ADDENDUM NO. 6

October 15, 2024

CORNER CANYON HS FIELD HOUSE

Addendum #6

OVERALL SITE LAYOUT PLAN

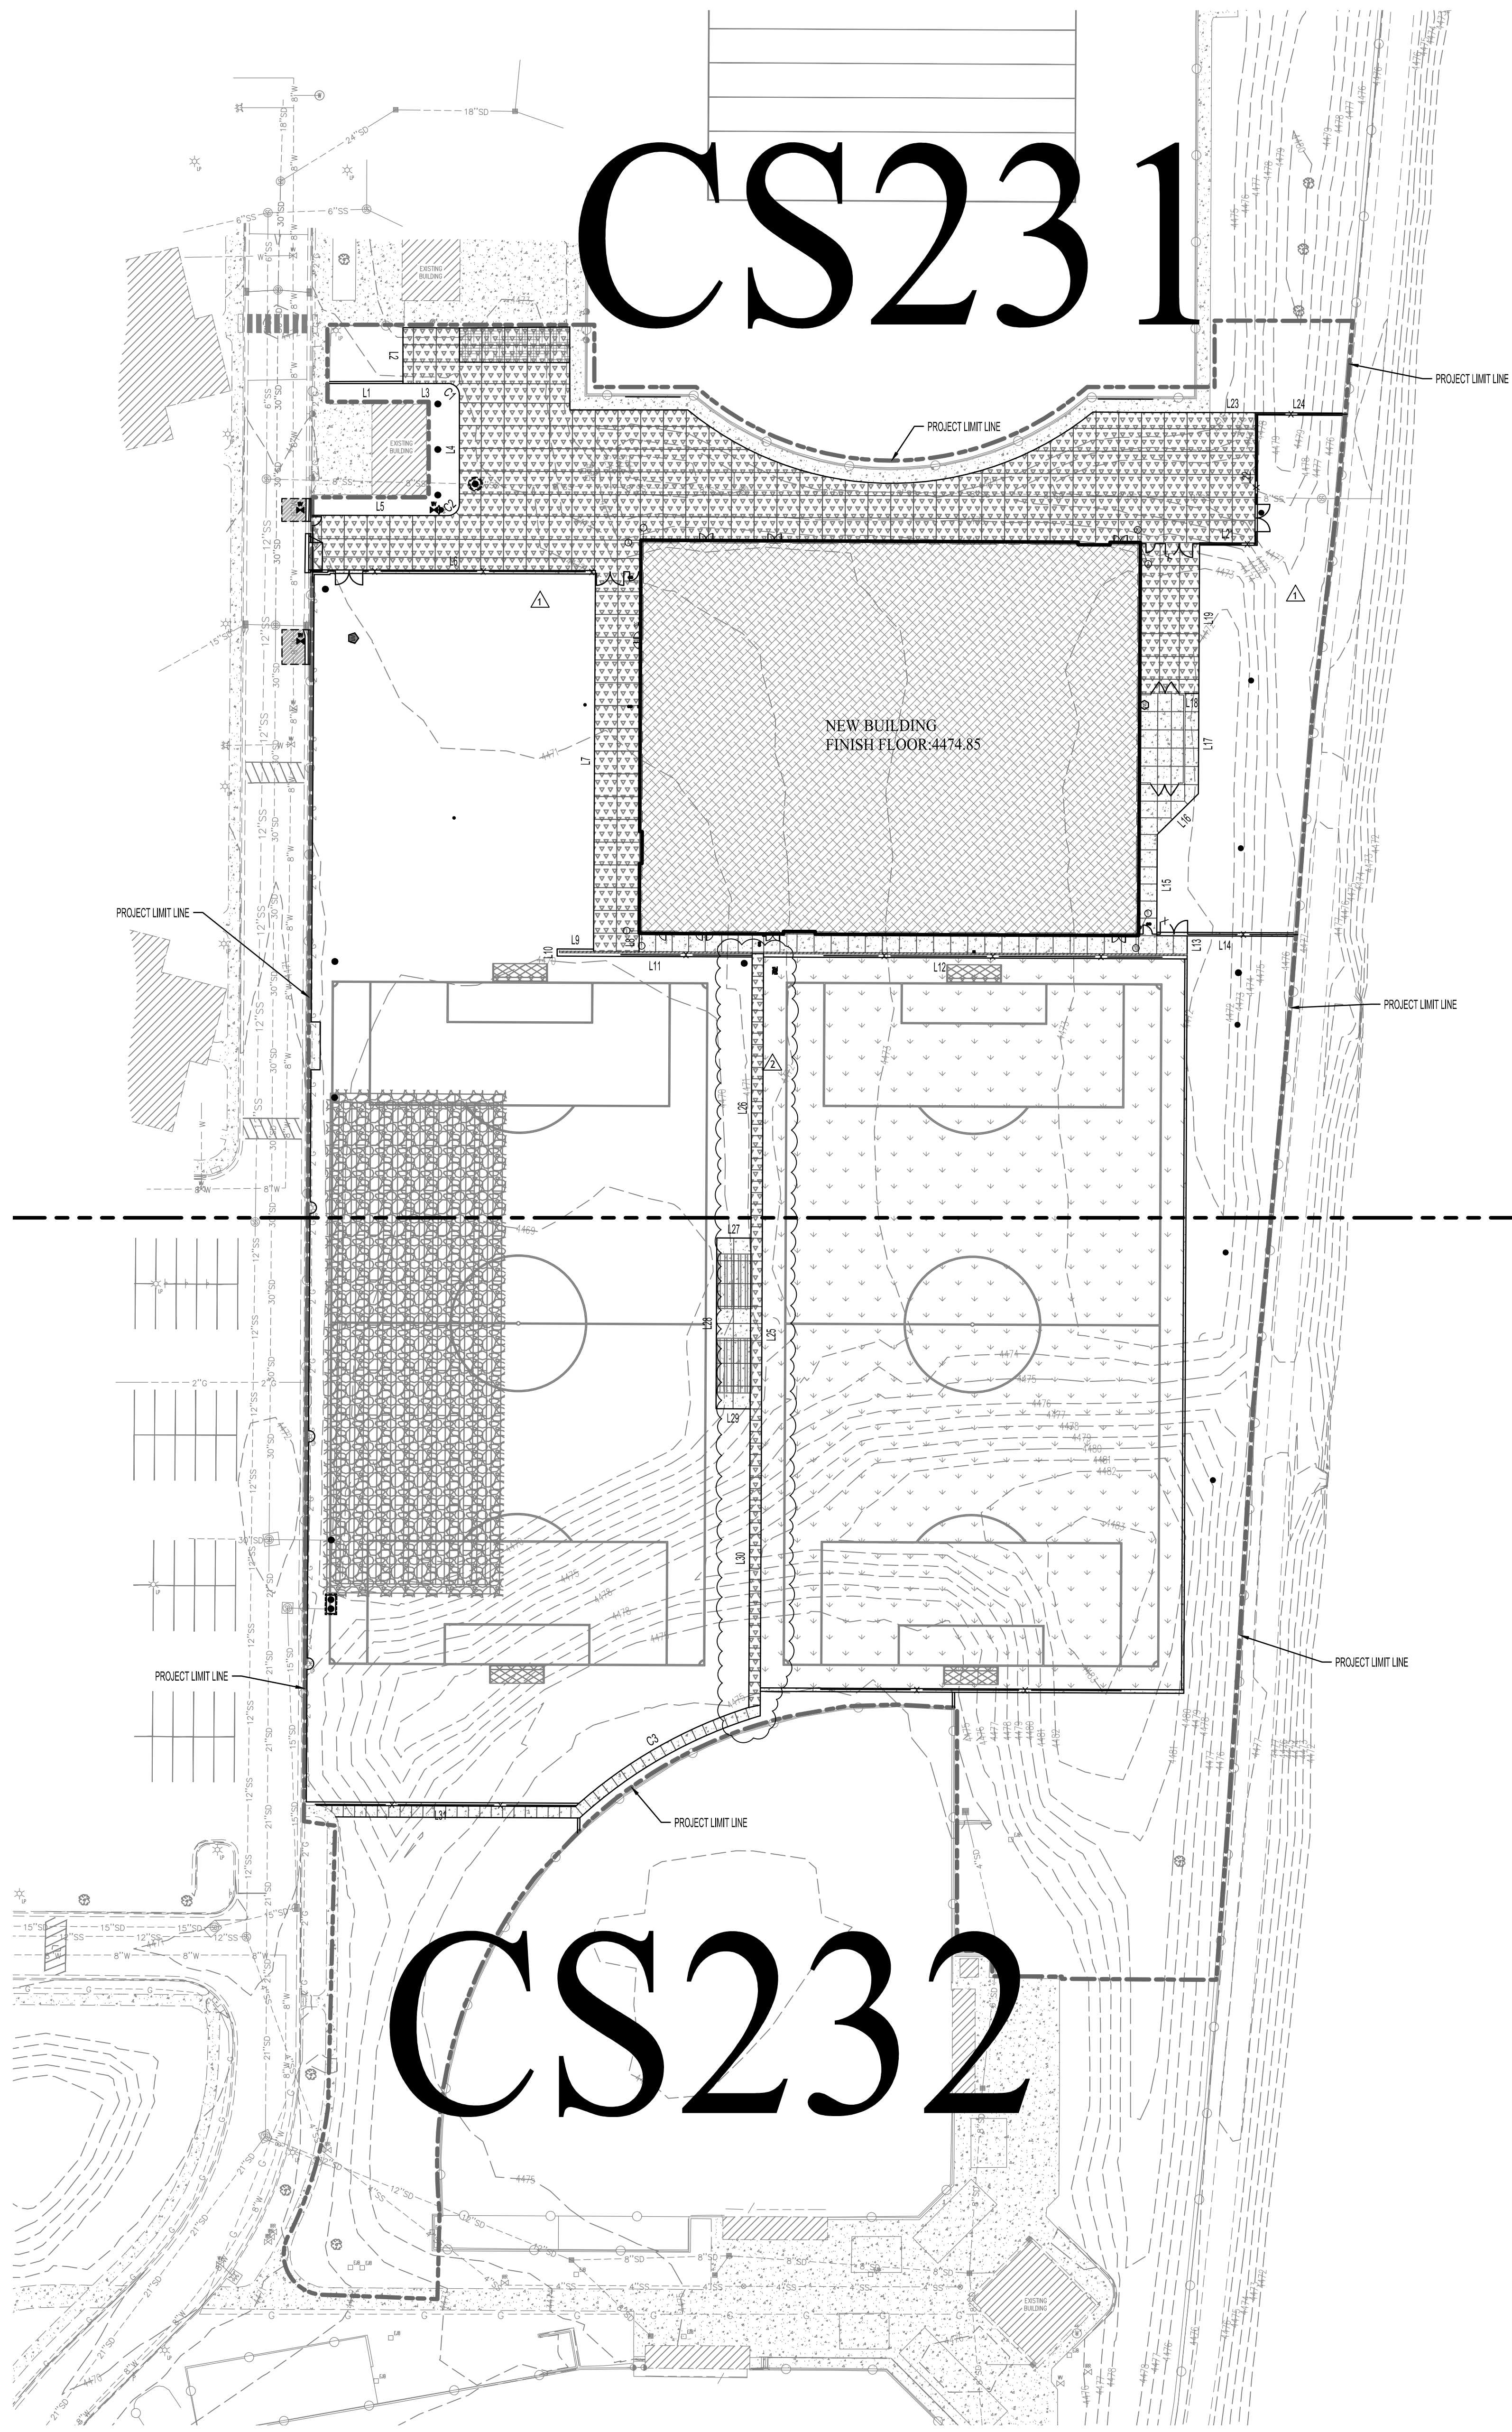
CS230

- Revised Sidewalk to Vehicle Concrete
- Added Note

SHEET NUMBER
CS231

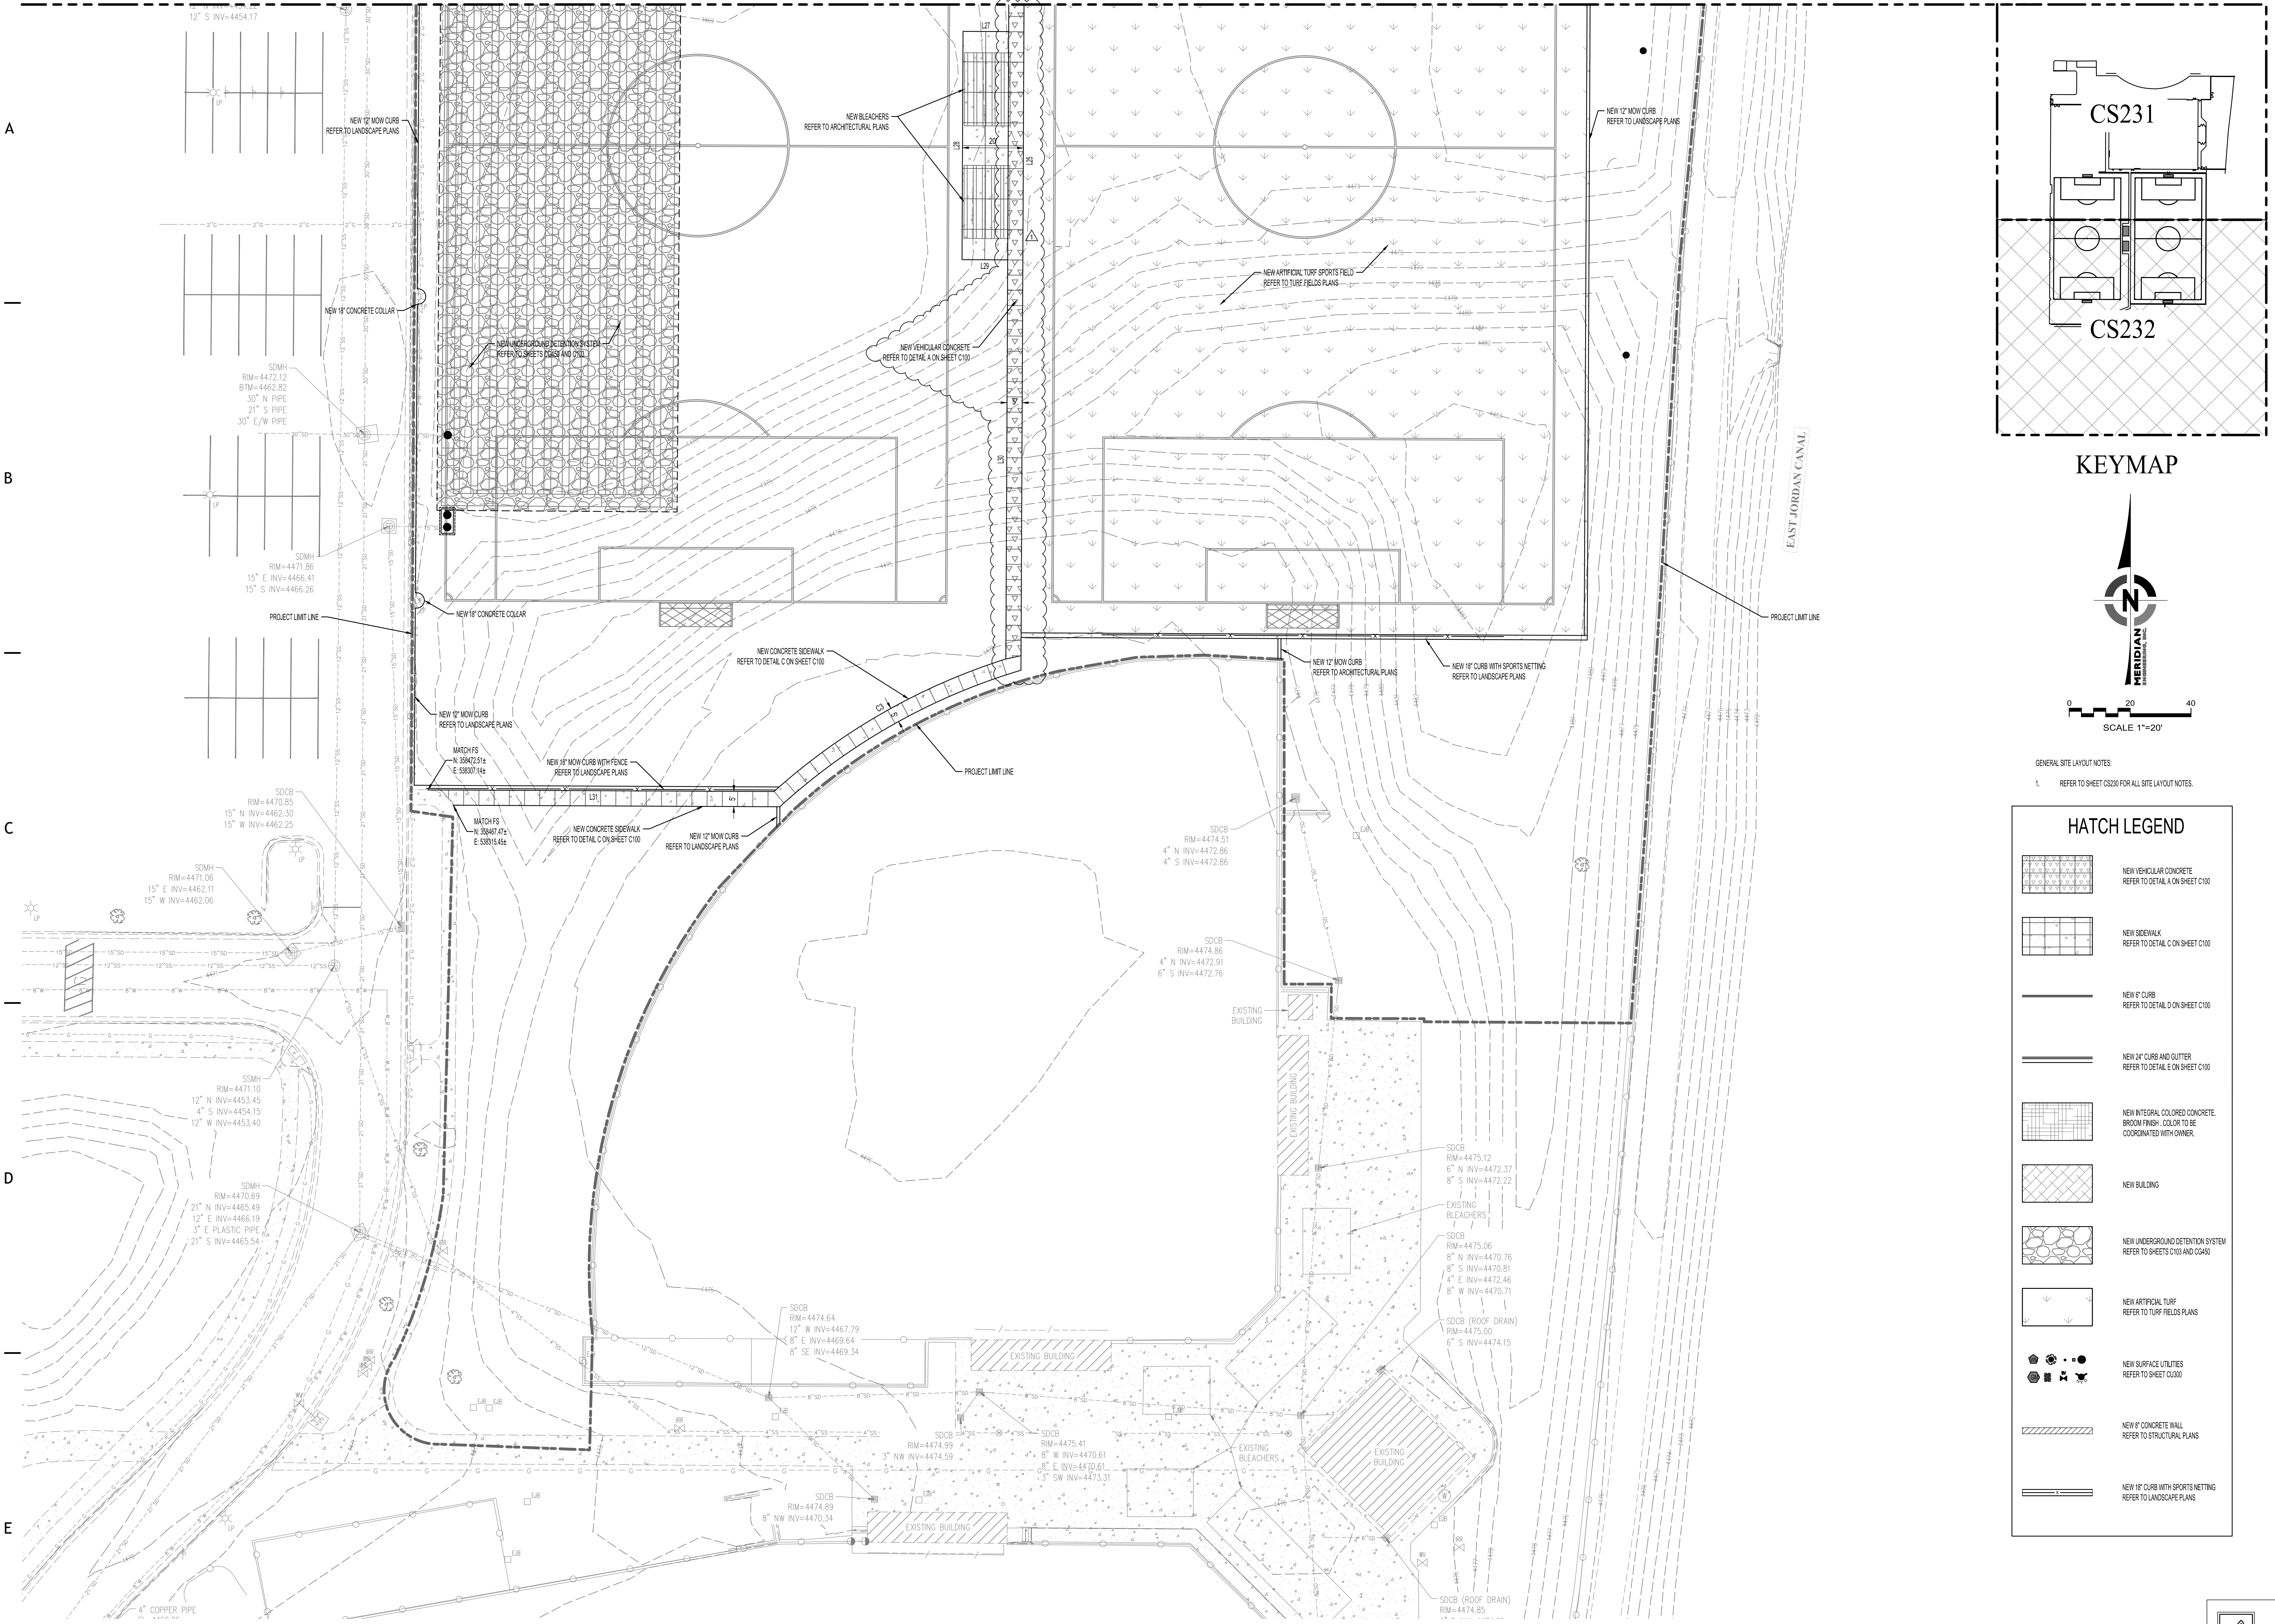
CS231

- Revised Sidewalk to Vehicle Concrete
